## **Written Representation on Sizewell C DCO application September 2020 and Changes January 2021**

Felixstowe Town Council (FTC) welcomes the opportunity to submit this Written Representation concerning EDF's Application for a Development Consent Order granting Development Consent for The Sizewell C Project, including Changes submitted by EDF in January 2021 which were subsequently accepted by the ExA in April 2021

## B) TRAFFIC CONFLICTS – ALTERNATIVE ACCESS ROUTE TO FREIGHT MANAGEMENT FACILITY

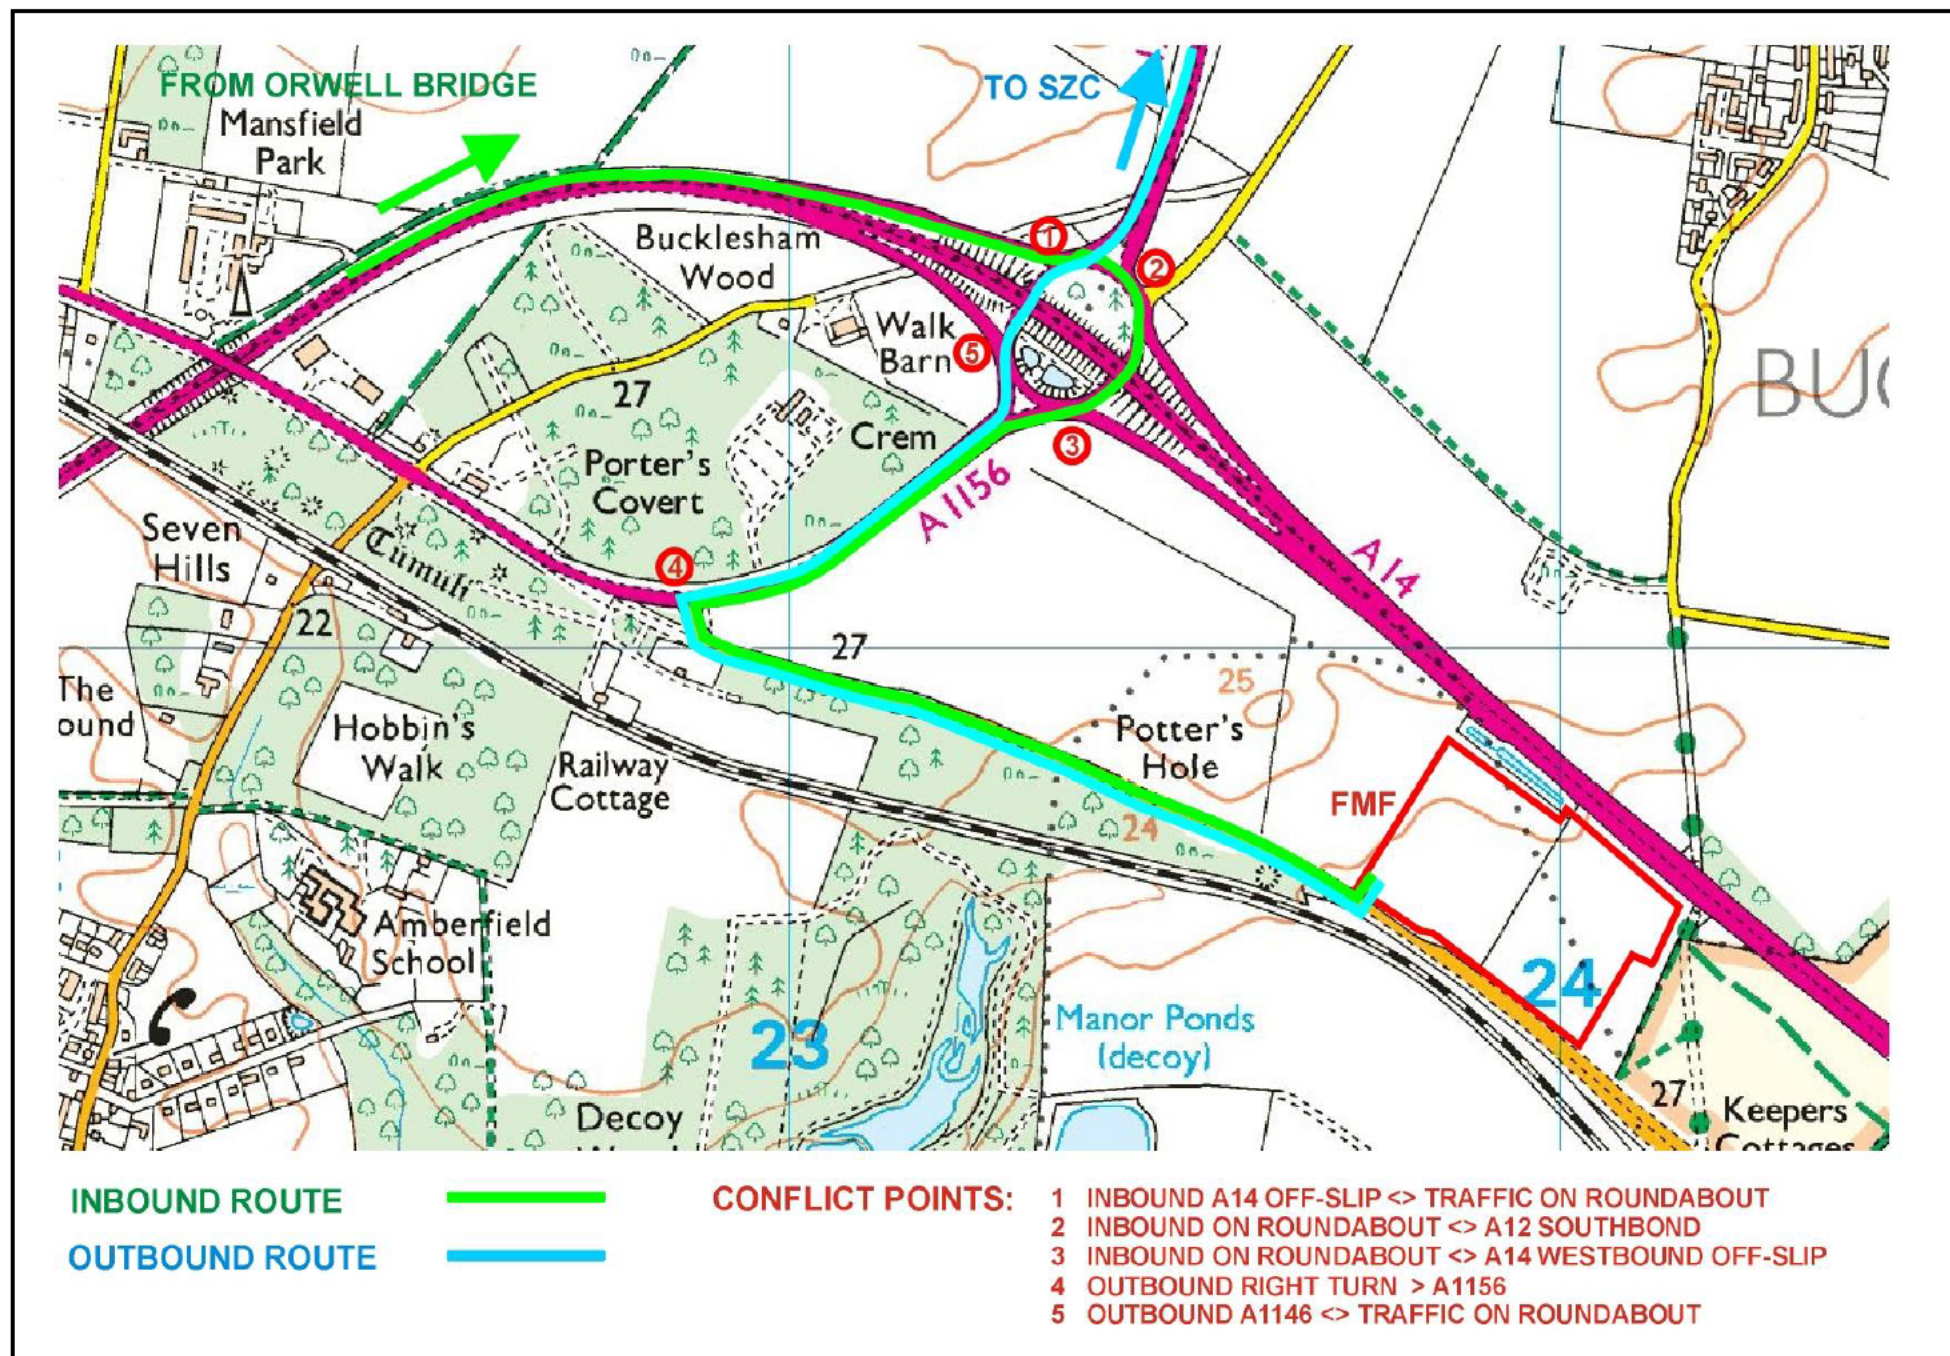
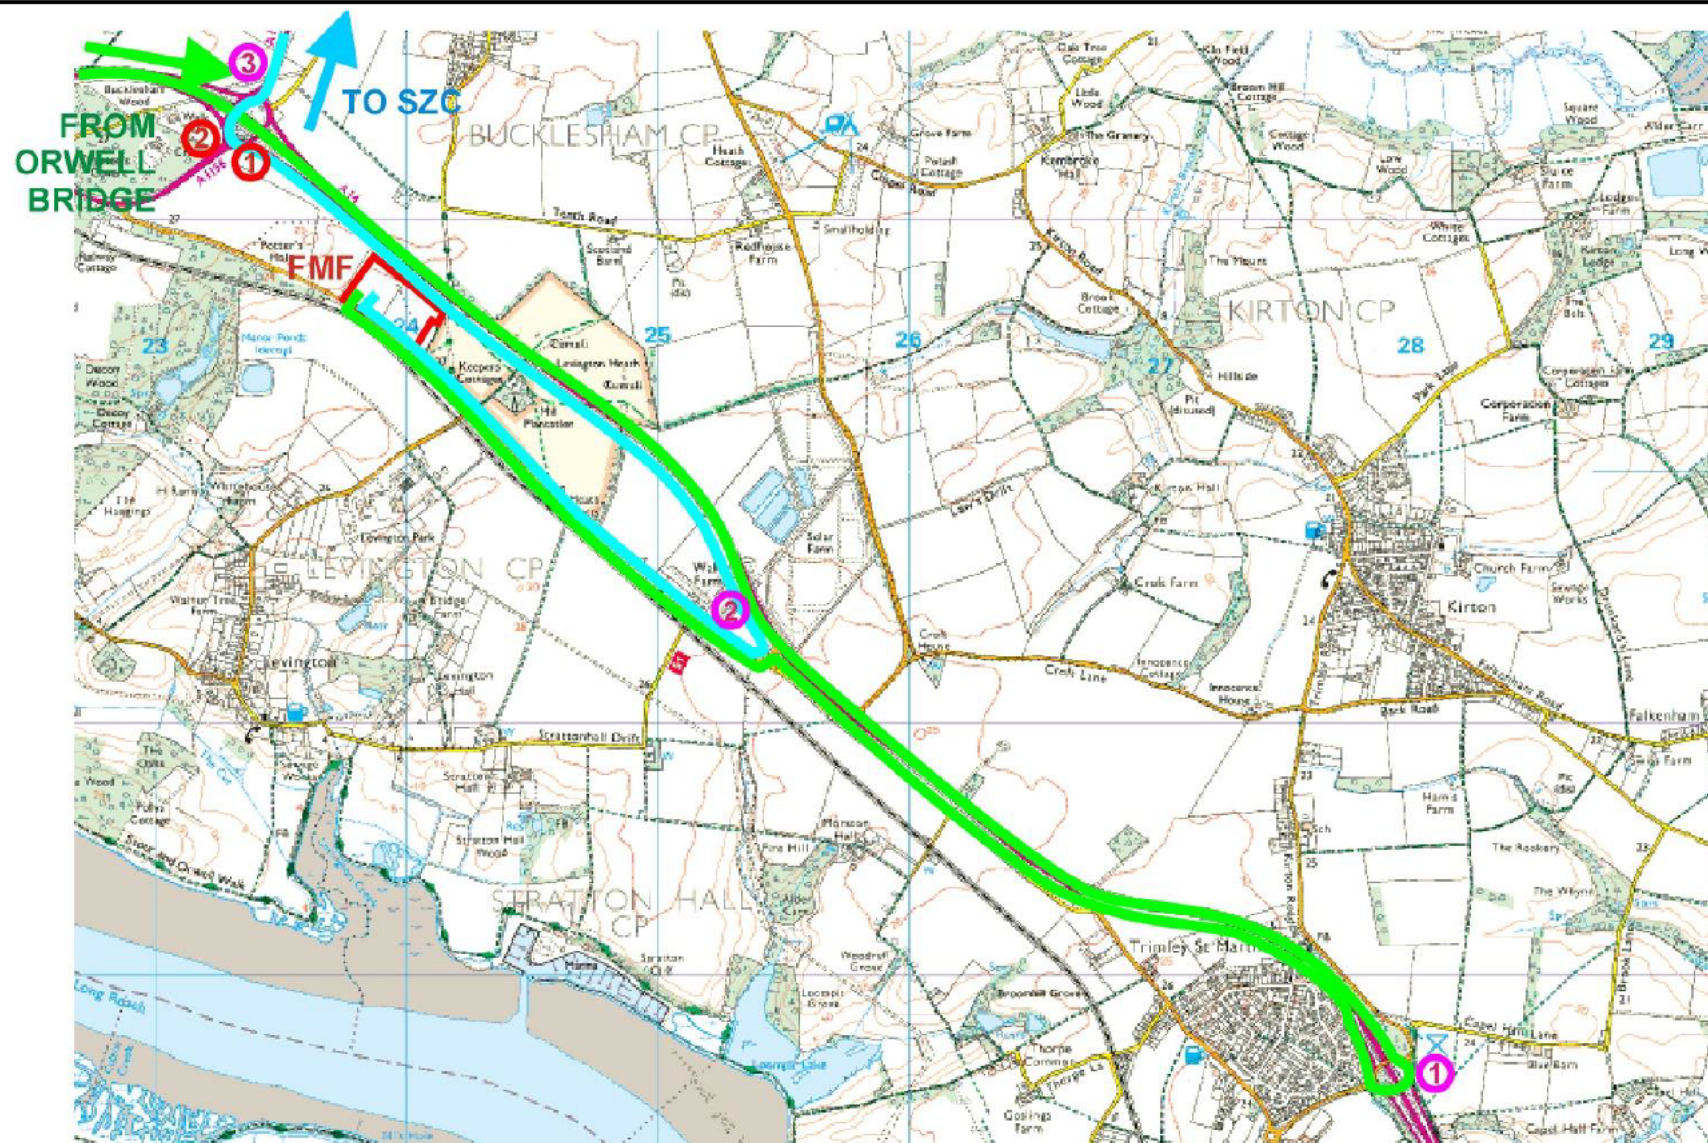
Also FTC have concerns about adding to the constantly growing traffic, with congestion at some times of day, by use of the Seven Hills junction on both Inbound and Outbound trips to the FMF, in addition to the traffic outbound southward from the SZC site, which can only be exacerbated by SZC LGV and HGV traffic using the junction on both northbound and southbound trips.

We believe that a much preferable option from a local traffic management perspective is to route FMF inbound by SZC traffic remaining on the A14 to the very lightly trafficked Trimley overpass roundabout (J59), and then westbound on the A14 to the existing full standard off-slip at Levington.

And similarly, to route FMF outbound traffic briefly eastwards to the Levington (local standard) A14 on-slip, then via Seven Hills roundabout to the A12 northbound.

We suggest this can be analysed by defining points at which on each option there are "Traffic Conflicts" on the routes. The 2 diagrams below illustrate this and show that those conflicts could be reduced from 5 to 2 by the alternative route proposal, as well as wholly eliminating the accident potential at Crematorium Junction. In this context "Traffic Conflicts" are defined as points where the SZC traffic would need to pass in front of or merge with existing significant traffic flows, so potentially either being delayed and / or itself suffering delays. Interference with minor flows, e.g. the single track Bucklesham exit from J58 are not included.

**CONFLICT POINTS:** 1 OUTBOUND A14 WESTBOUND OFF-SLIP <> TRAFFIC ON ROUNDABOUT  
2 OUTBOUND ON ROUNDABOUT <> A1156 EASTBOUND

**NOTES:** 1 NO CONFLICT - TRIMLEY ROUNDABOUT HAS MINIMAL TRAFFIC  
2 LEVINGTON LOCAL ON-SLIP IS SHORT, MAY NEED UPGRADE  
3 LIMITED CONFLICT A12 NORTHBOUND DUE TO A12 LEFT FILTER LANE
